RESOLUTION R-93-25 RESOLUTION GRANTING AN AMENDED DEVELOPMENT ORDER

SECTION 1. AMENDMENT OF DEVELOPMENT ORDER FOR DRI NO. 13, R-85-219.

SECTION 4. AMENDMENTS TO APPROVED DEVELOPMENT

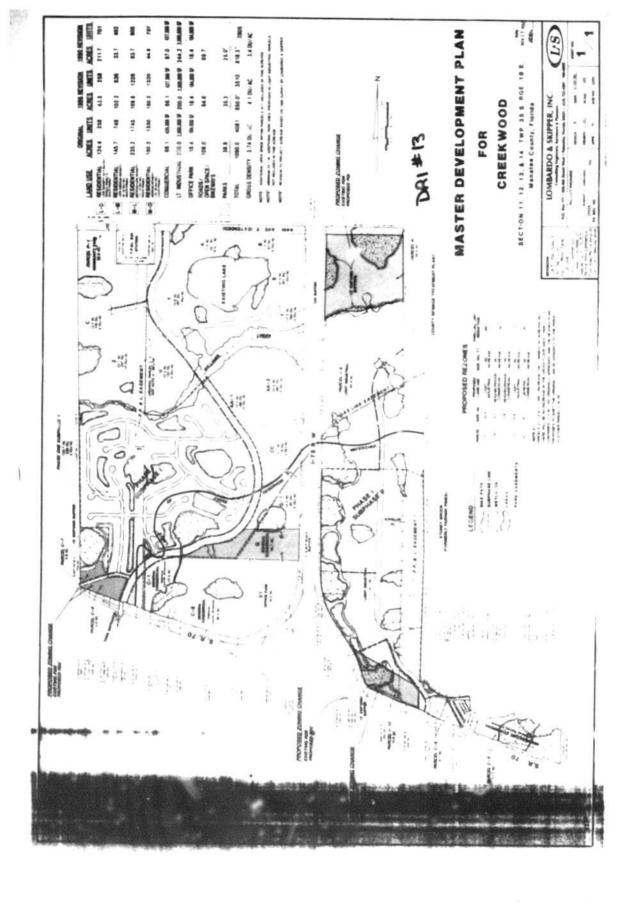
- H. Amending the site plan to change the zoning and land use of a 6.8 acre parcel located at the southwest corner of the project from Planned Development Residential (PDR) to Planned Development Commercial (PDC) with no increase in the project's overall intensity; and

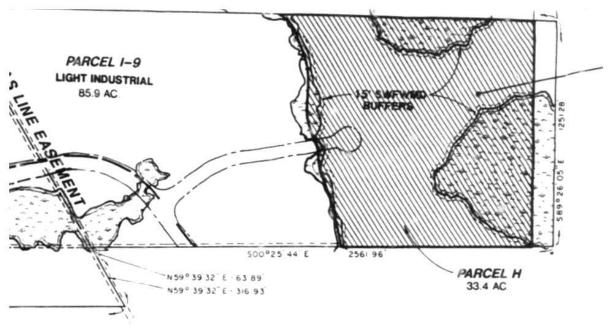
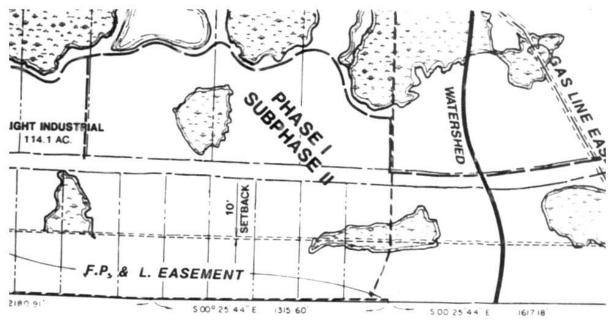
- A. Amending the site plan (Exhibit "C") to dedicate a 25 acre community park at the northwest corner of the project; and
- B. Amending the site plan to reconfigure and relocate an approved 10.8 acre park located at the northeast corner of I-75 and State Route 70 to a 24.7 acre linear park located parallel to and east of I-75; and

- C. Amending the site plan to relocate 7500 sq. ft. of approved commercial floor area from the interior of the project west of I-75, to the approved commercial area fronting State Route 70 west of I-75; and

- D. Amending the site plan to provide two (2) additional access points to State Road 70 and to relocate existing access points on State Route 70; and
- E. Amending stipulation #2 of the Buffer Conditions to decrease the building setback adjacent to the power line easement from 50 feet to 10 feet; and

PROPOSED ZONING CHANGE
EXISTING PDR
PROPOSED PDI

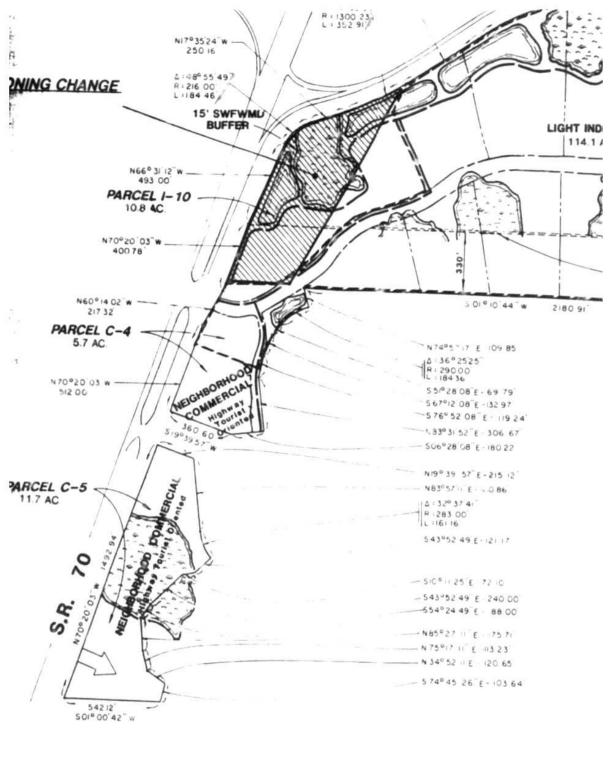
- K. Amending the zoning and land use of a 33.4± acre parcel located east of Interstate 75 and approximately one (1) mile north of State Road 70, from Planned Development Residential (PDR) to Planned Development Industrial (PDI) with no increase in the projects overall intensity; and

- L. Reduction of a 100 foot wide buffer to 30 feet in width adjacent to the east side of Interstate 75 approximately one (1) mile north of State Road 70; and
